# Peer Review

Moorabool Shire Flood Studies

Prepared for  
Moorabool Shire Council

**Attachment 1: Peer Review – Moorabool Shire Flood Studies**

Figure 4-2 Exhibited SBO Extent, near Masons Lane

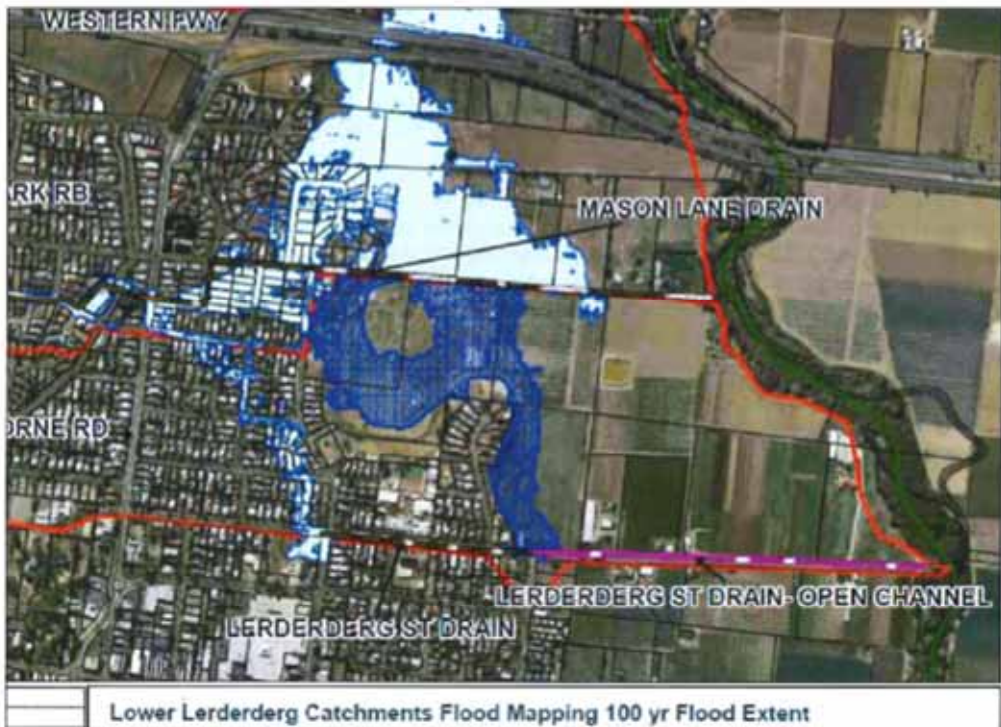
- > It was noted that the flood extent as exhibited, south of the Western Freeway, covers the entirety of the farming land between Mason's Lane and Lerderg Street as shown in Figure 4-2. This flood shape does not match that shown in the Engeny report for this location (Figure 1 in the Engeny report, reproduced here as Figure 4-3). This is likely due to the flood extent in this area being created using a process that is now deprecated by Melbourne Water.

In our view, flood extents generated using the point density method should not be used in planning scheme overlays. It is recommended that the flood extents generated in the Lower Lerderg catchments be re-examined and updated as necessary based on Melbourne Water's updated process to determine flood extents. The appropriate starting point would be the flood extents shown in the Lower Lerderg Catchments Flood Mapping report, Figures 1 and 2.

Cardno considers that the proposed SBO extent does not appropriately reflect the results of the flood modelling for the Lower Lerderg area. The proposed SBO should be modified to reflect the actual results of the flood modelling.

Figure 4-1 Proposed Overlay

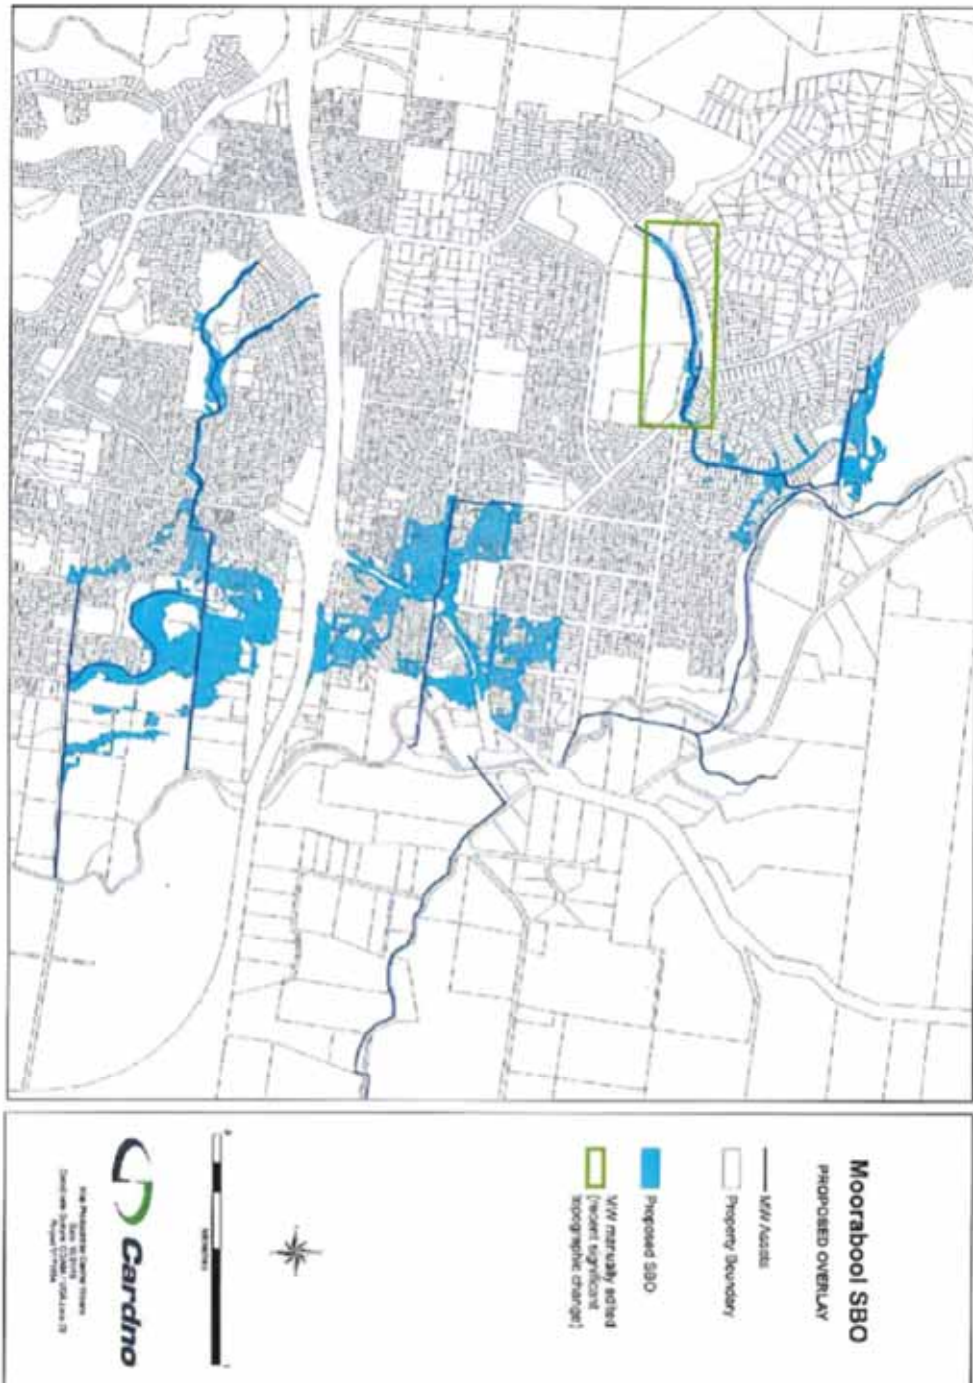
The revised Special Building Overlay is shown on Figure 4-1 overleaf.

It is recommended that the proposed SBO is adopted and the planning scheme amendment process be recommenced.

Figure 42 Overlay Comparison

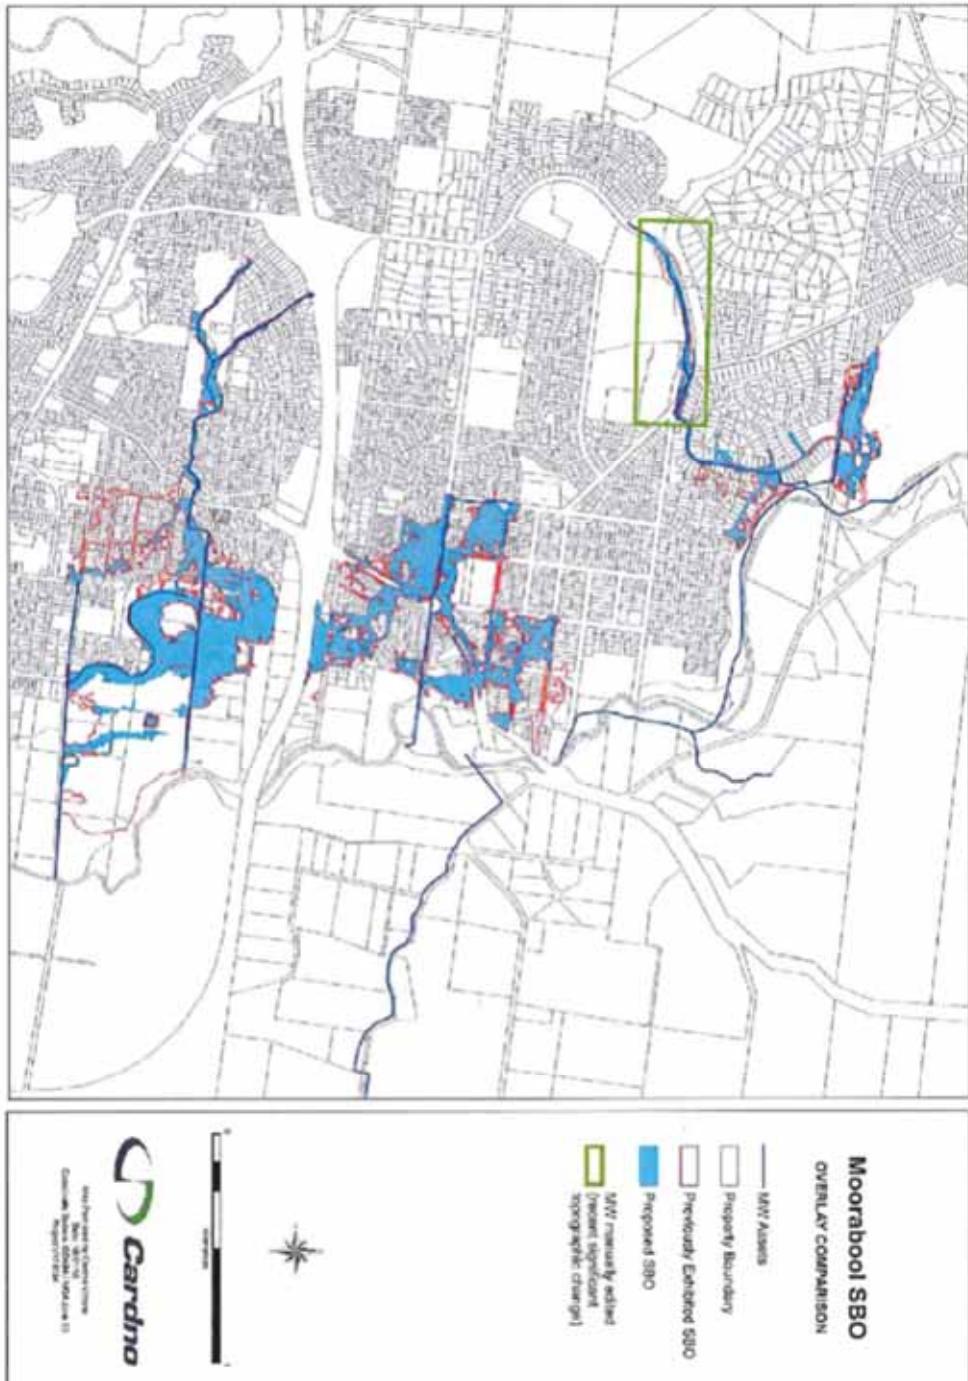
Figure 4-2 shows this proposed overlay alongside the previously exhibited overlay. Whilst there are a number of changes, the key area of change is in the rural land south of Masons Lane. The proposed overlay is significantly reduced from that which was previously exhibited.
